ADDENDUM NO. 1

ADVERTISED BID NO. 1011-157
PUBLIC WORKS PROJECT NO. 5.0609

WASTEWATER RECLAMATION PLANT
NORTH LIFT PUMP STATION IMPROVEMENTS

ADDENDUM NO. 1
TO
ADVERTISED BID NO. 1011-157
PUBLIC WORKS PROJECT NO. 5.0609
NOVEMBER 22, 2010

REVISION TO DRAWING C-3

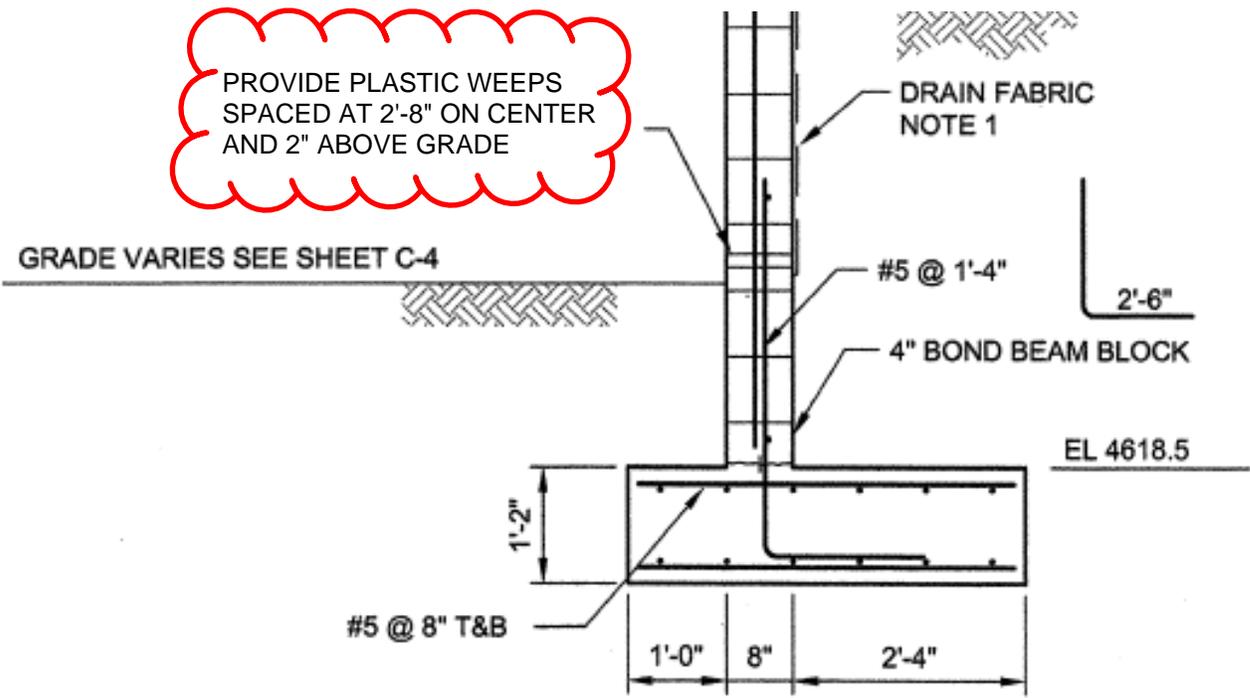
PROVIDE PLASTIC WEEPS
SPACED AT 2'-8" ON CENTER
AND 2" ABOVE GRADE
